Commonwealth Edison
One First National Plaza, Chicago, Illinois
Address Reply to: Post Office Box 767
Chicago, Illinois 60690

Subject: Braidwood Station Units 1 and 2
Additional FSAR Information
NRC Docket Nos. 50-456/457

The Attachment to this letter provides our response to Questions 330.2, 371.7, 371.8, 371.11, and 371.13 through 371.15. Our FSAR will be amended to include the information contained in the Attachment to this letter as appropriate. Additionally, our schedule for submittal of the remaining open items is currently being discussed with Ms. Janice A. Stevens.

BRAIDWOOD-FSAR

FIGURE 2.1-11

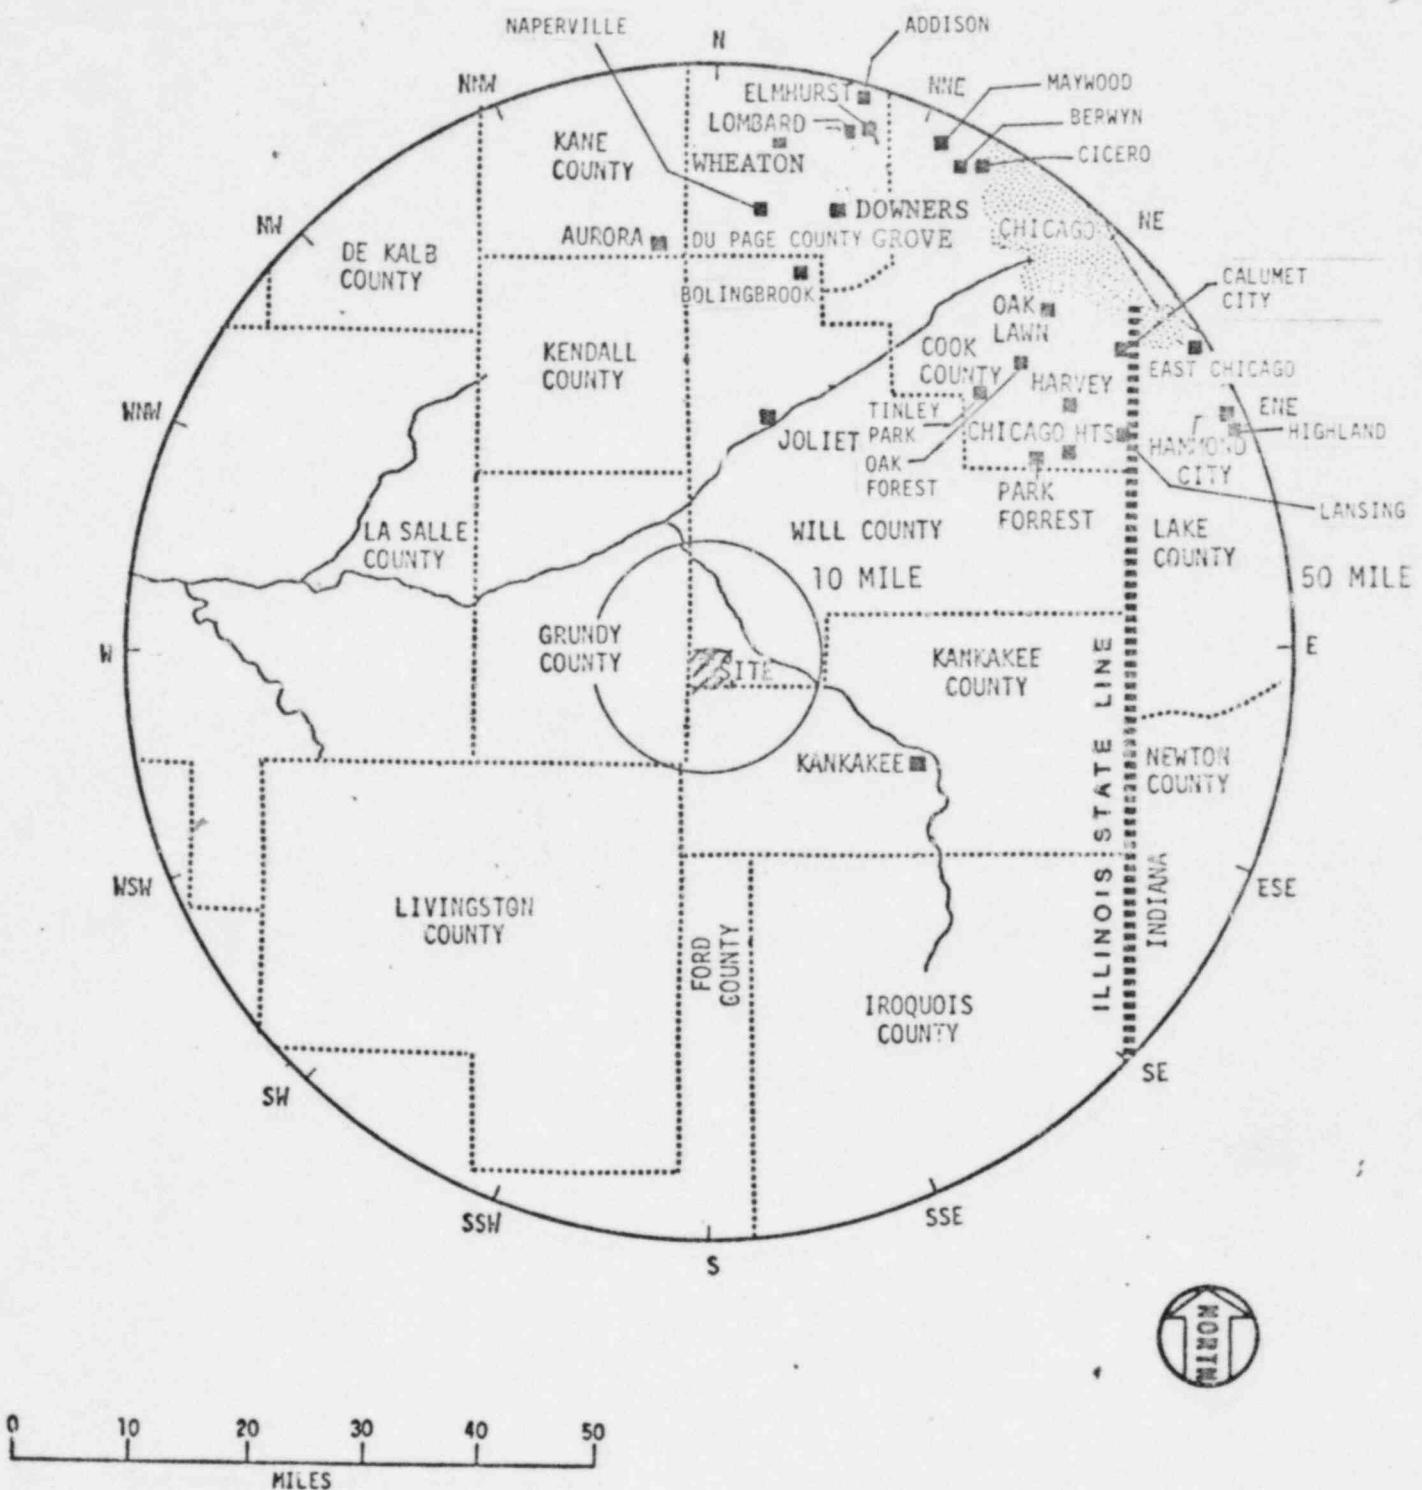
"Please provide an update to the population data shown in Section 2.1 to reflect the 1980 Census data."

As requested, Tables 2.1-2, 2.1-3, 2.1-7, 2.1-8, 2.1-9, and 2.1-10, and Figures 2.1-8, 2.1-11, and 2.1-12 have been revised. Subsections 2.1.3 and 2.1.4 have also been revised.

BRAIDWOOD STATION
FINAL SAFETY ANALYSIS REPORT
FIGURE 2.4-5

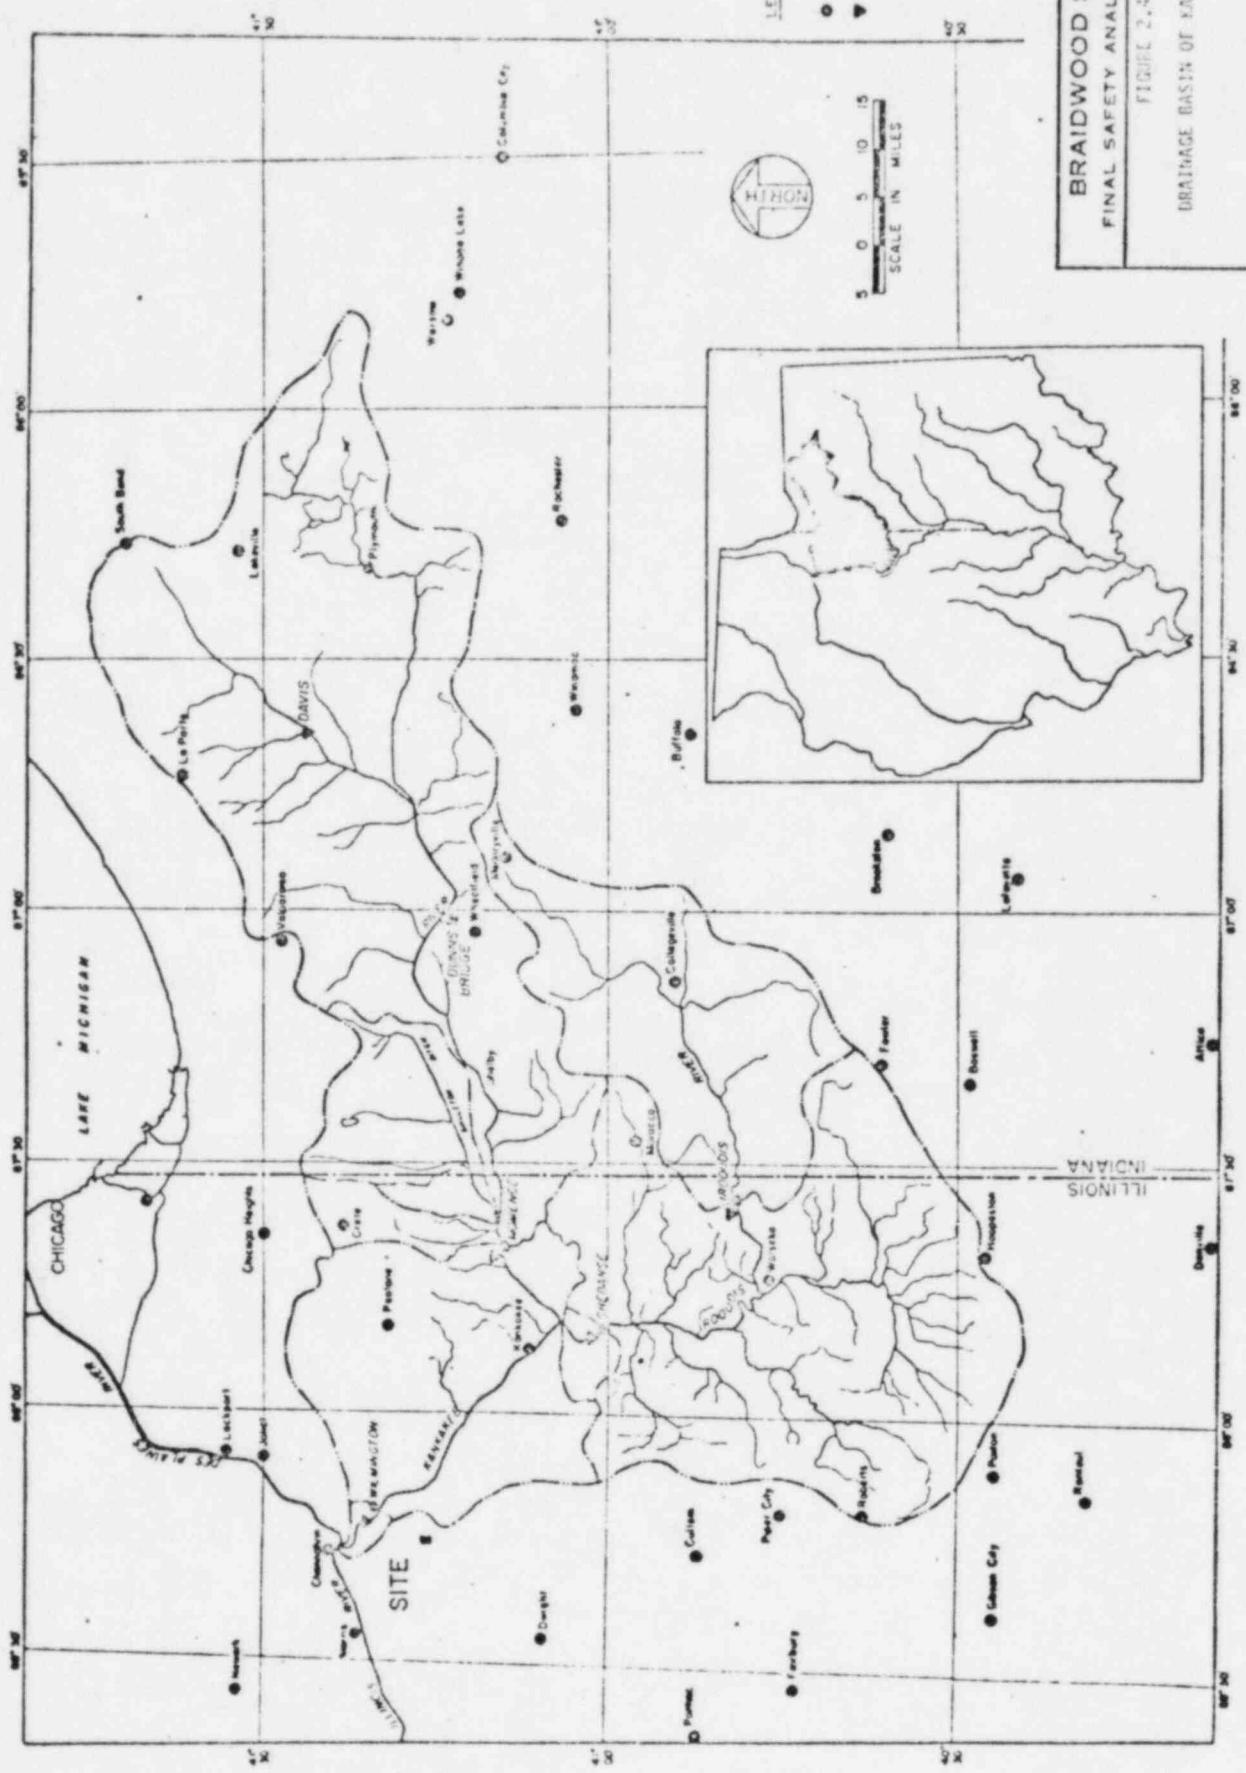
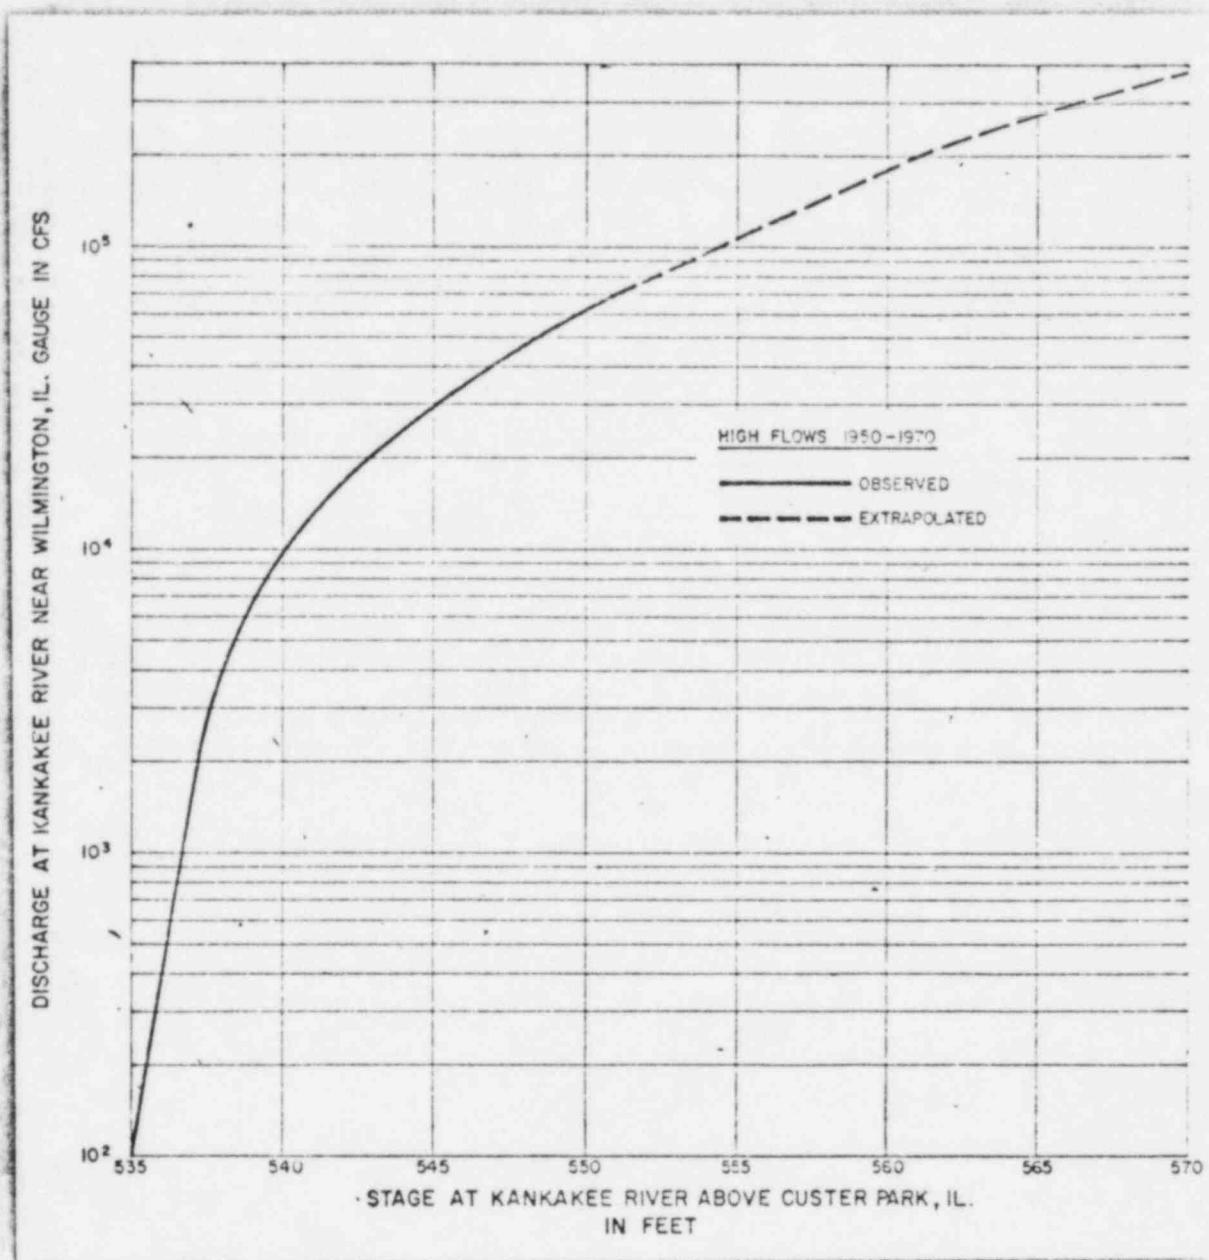
"Show the site location on Figure 2.4-5 and provide the drainage area of the Kankakee River upstream of the site."

See revised Figure 2.4-5. The drainage area of the Kankakee River at the location of the river intake is 5000 mi² (see Subsection 2.4.11.3).

FIGURE 2.4-9

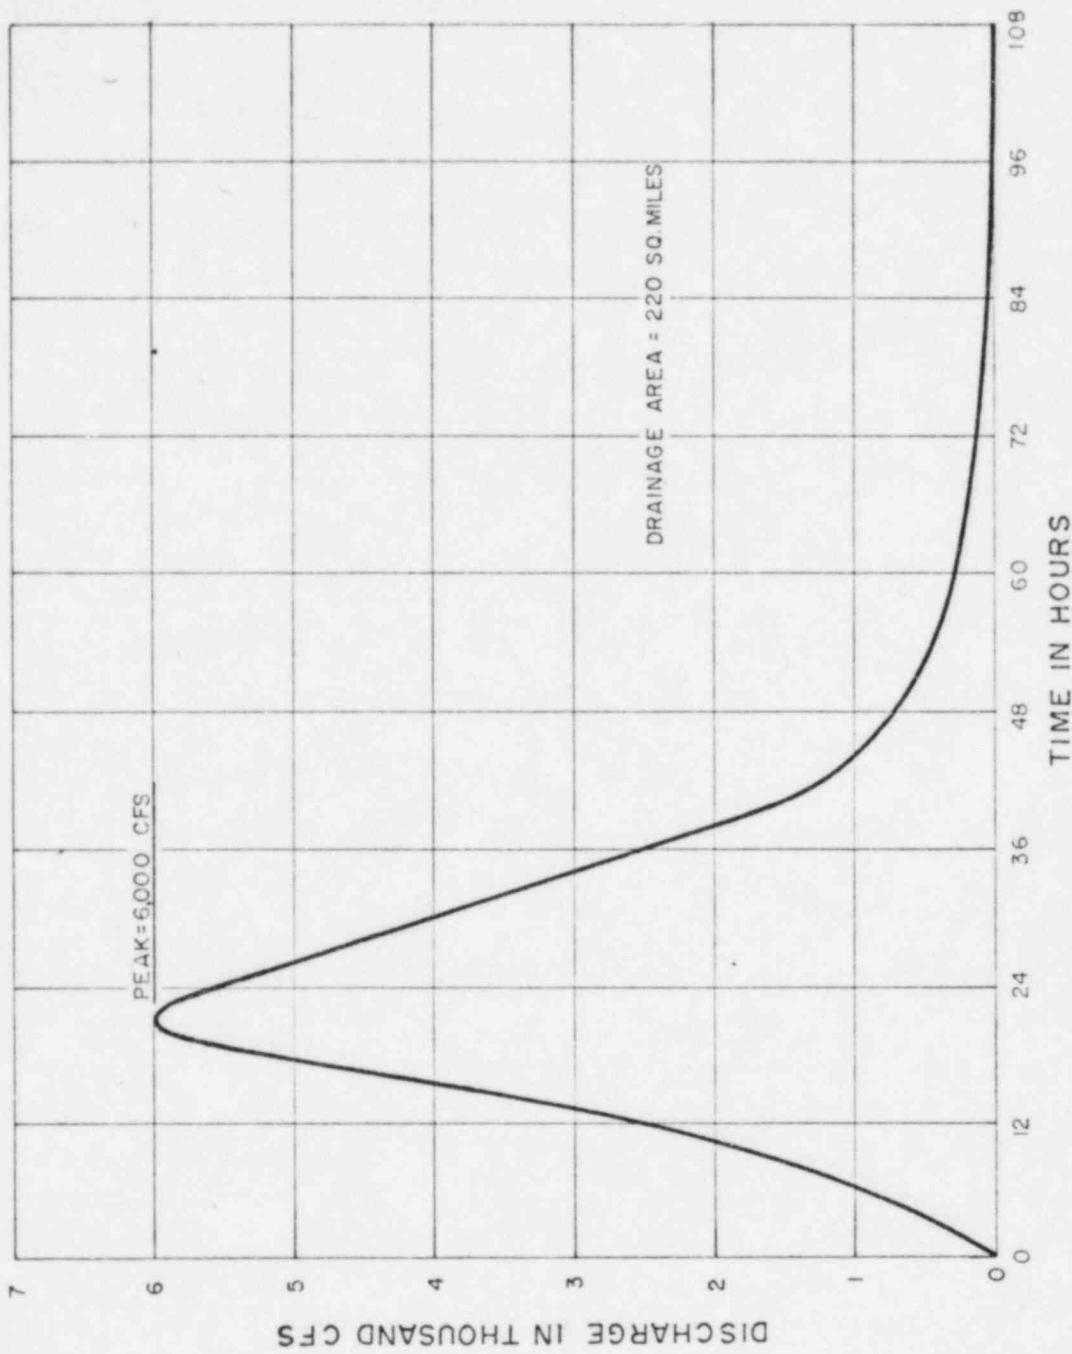
- "1. Provide additional clarification on the method used to develop the Kankakee River rating curve at the site from data at Wilmington and Custer Park and also explain how the curve was extrapolated to PMF levels. Provide a cross section of the Kankakee River at the site. If the channel cross section is not available, then provide the bankfull capacity and indicate the bankfull width on the overbank cross section.

The peak discharge of record at Wilmington, Illinois is 75,900 cfs with a corresponding peak stage of 551.5 at Custer Park, Illinois and 522.26 feet at Wilmington, Illinois. The distance between the two gauging stations is 9.4 miles. Therefore, the water surface slope of the Kankakee River for a flow of 75,900 cfs is computed to be 0.000589. Using this water surface slope and the typical cross section of the river shown in Figure 2.4-14a the Manning's "n" value is computed to be 0.03, corresponding to the flow of 75,900 cfs. The water surface elevations in the river cross section were obtained for higher flows of 209,000 cfs and 400,000 cfs using the above values of Manning's "n" and the water surface slope, and the discharge rating curve is extrapolated as shown in Figure 2.4-9.

FIGURE 2.4-13

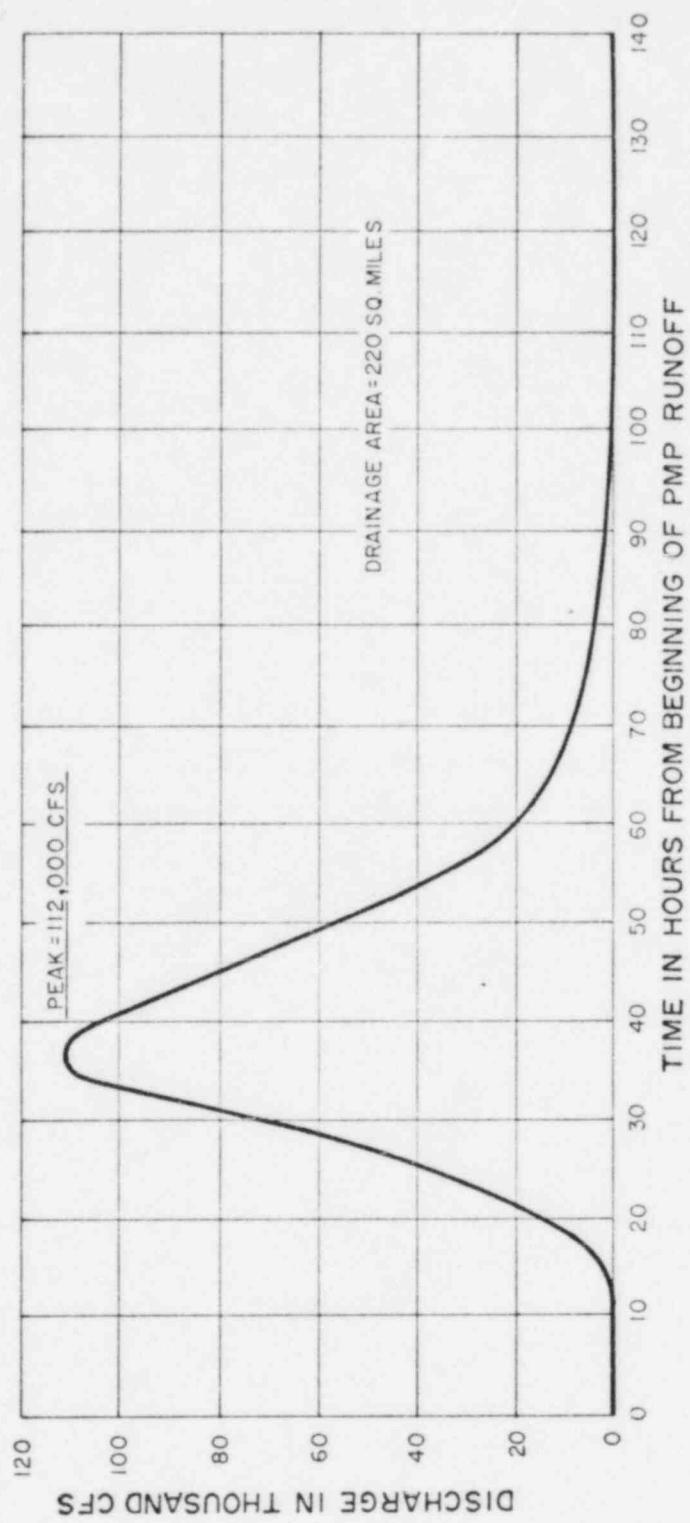
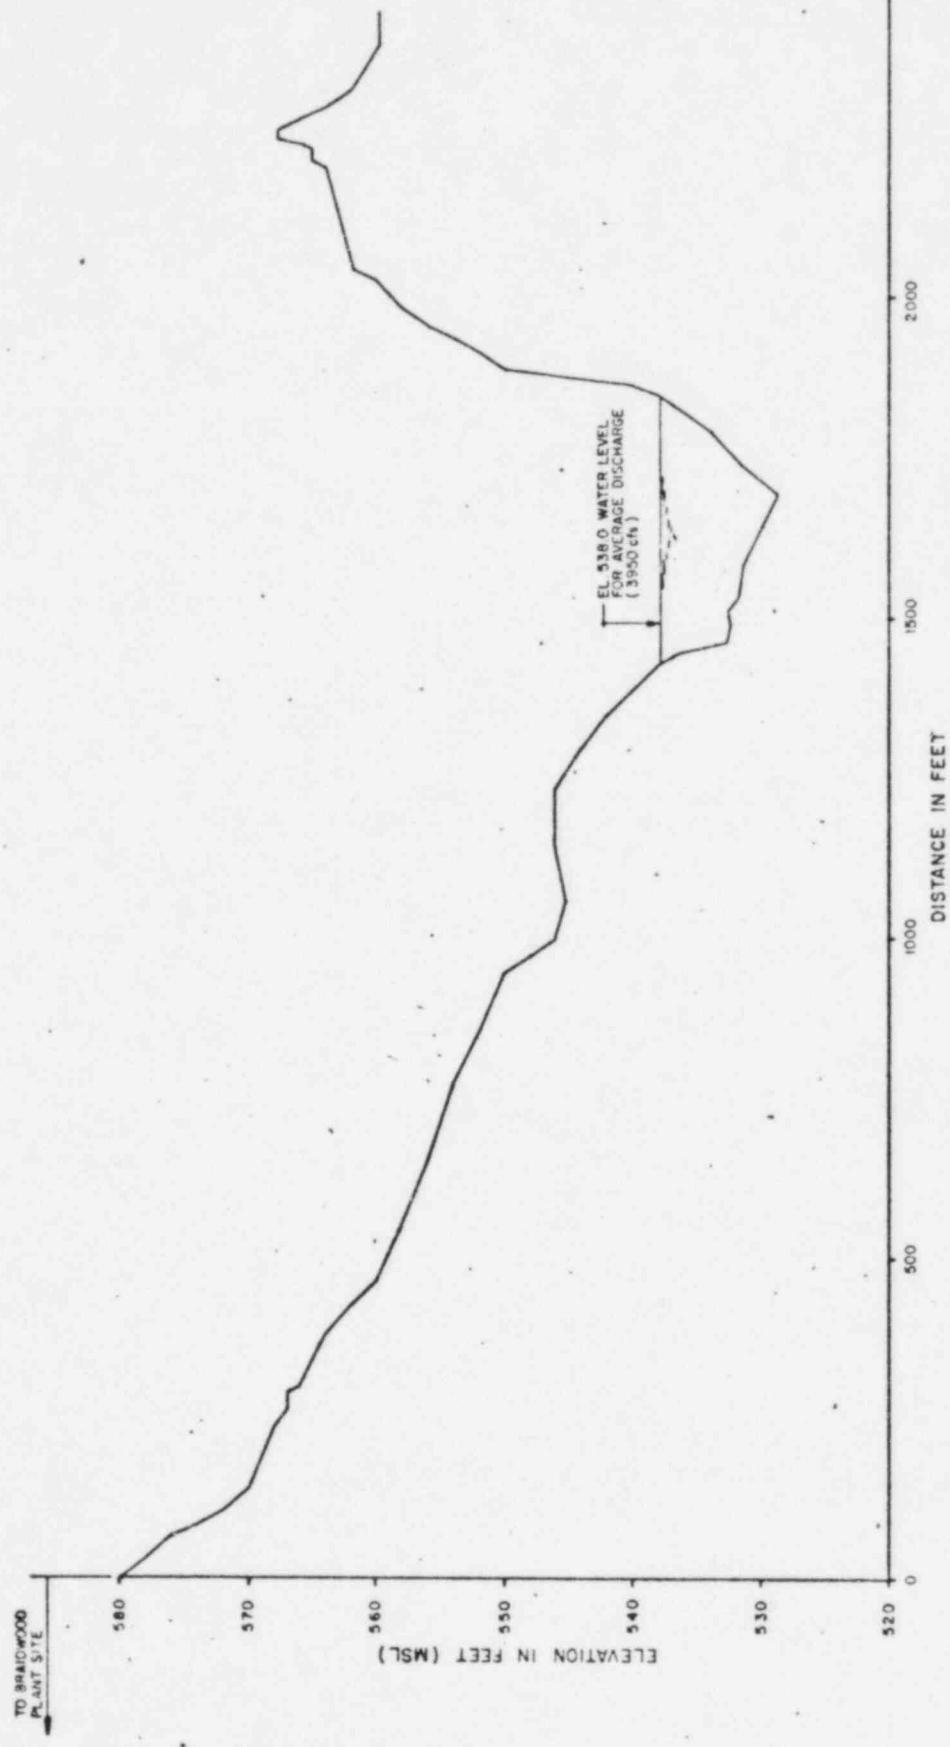
- "2. It appears that your PMF peak discharge estimates are not consistent with cross section locations on Granary Creek and Mazon River; e.g., the PMF discharge should be evaluated at the cross section location where the design basis water level is determined. The Mazon River PMF peak discharge should be computed for the drainage area above cross section X-MD2. The Granary Creek PMF peak discharge and cross section should be furnished for a point just upstream of the confluence of the East Fork and Granary Creek. Also provide the energy gradient at X-MD2 and at the new X-section on Granary Creek."

- Item 2: The peak PMF discharges for Mazon River and Granary Creek are presented in the FSAR at the locations where the design basis water level is determined. The Mazon River PMF peak discharge is 112,000 cfs at cross section X-MD2 with a corresponding water level of 581.5 feet as shown in Table 2.4-8. The PMF peak discharge in Granary Creek just upstream of its confluence with East Fork Mazon River is 19,500 cfs and the corresponding water level is 576.0 feet as presented in Subsections 2.4.3.4, 2.4.3.5, and Table 2.4-5. The energy gradients at cross section X-MD2 on the Mazon River and at the cross section of Granary Creek just upstream of its confluence with East Fork Mazon River are 0.000345 and 0.000746, respectively. The cross section of Granary Creek just upstream of its confluence with East Fork Mazon River is presented in Figure 2.4-17a. Subsection 2.4.3 has been revised to clarify the above information.
